## ORIGINATION FORM

Proposed Revisions to a Standard Plans Index  
(Please provide all information — Incomplete forms will be returned)

Index Number: 548-020

Index Title: MSE Retaining Wall Systems (Permanent)

**FDOT MSE RETAINING WALL CLASSIFICATION TABLE**

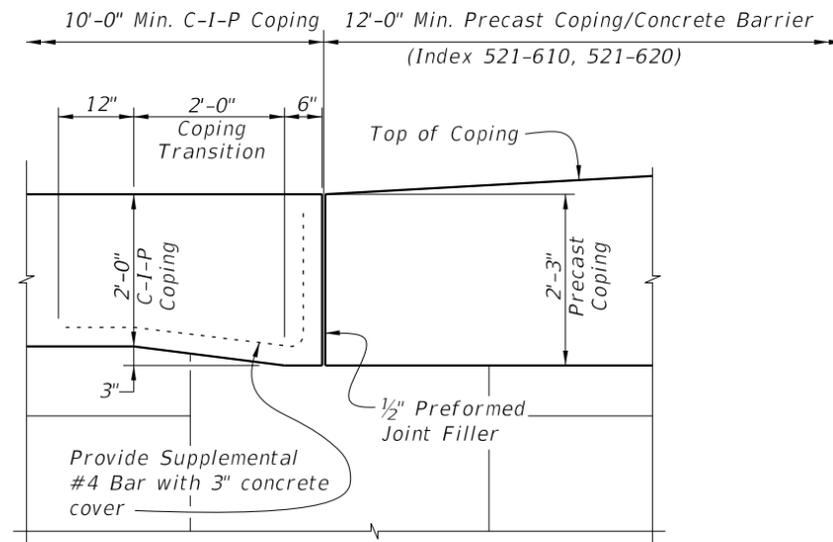
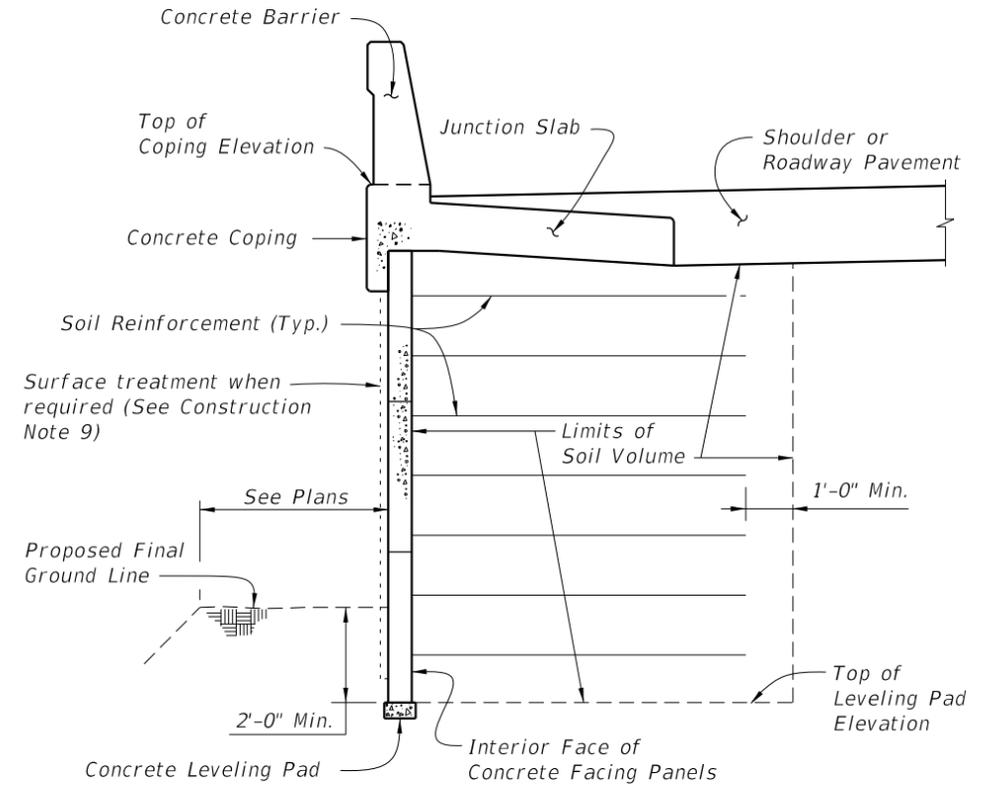
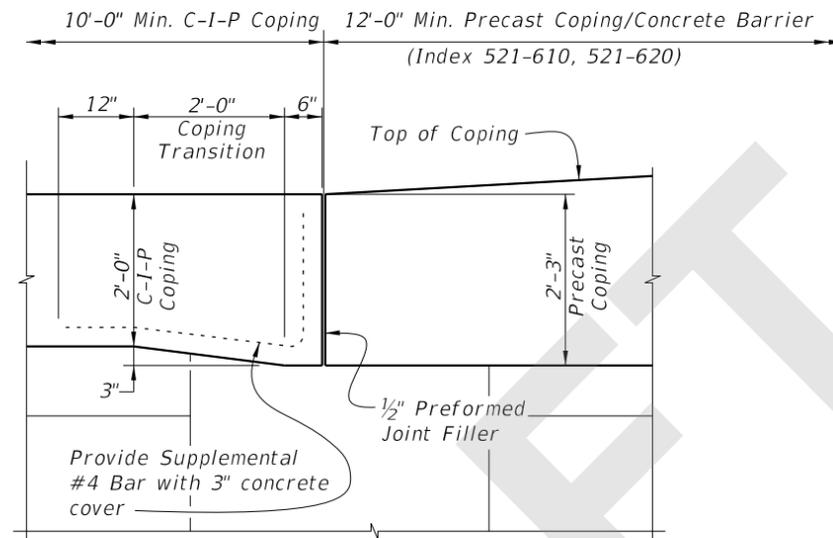
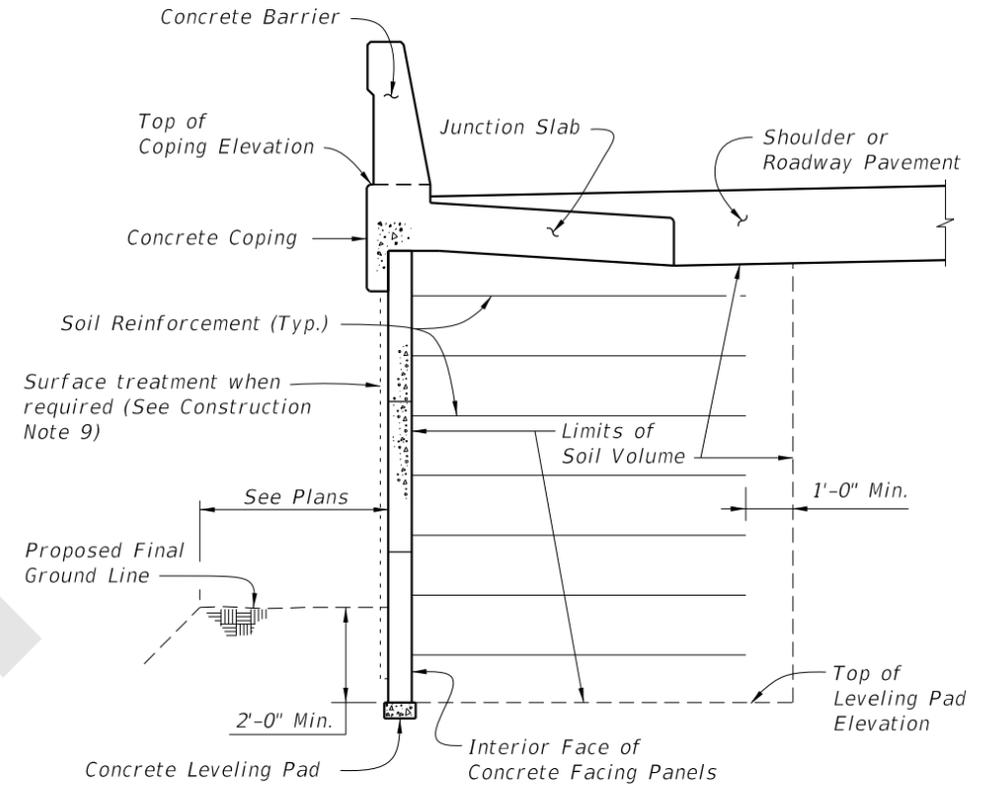
Change Silica Fume, metakaolin or ultra-fine flyash to Highly Reactive Pozzolans

Specification changed to fit silica fume, metakaolin and ultra-fine flyash under Highly Reactive Pozzolans

\*\* ~~Silica fume, metakaolin or ultrafine fly ash.~~

**Highly Reactive Pozzolans**

\*\* Highly Reactive Pozzolans.
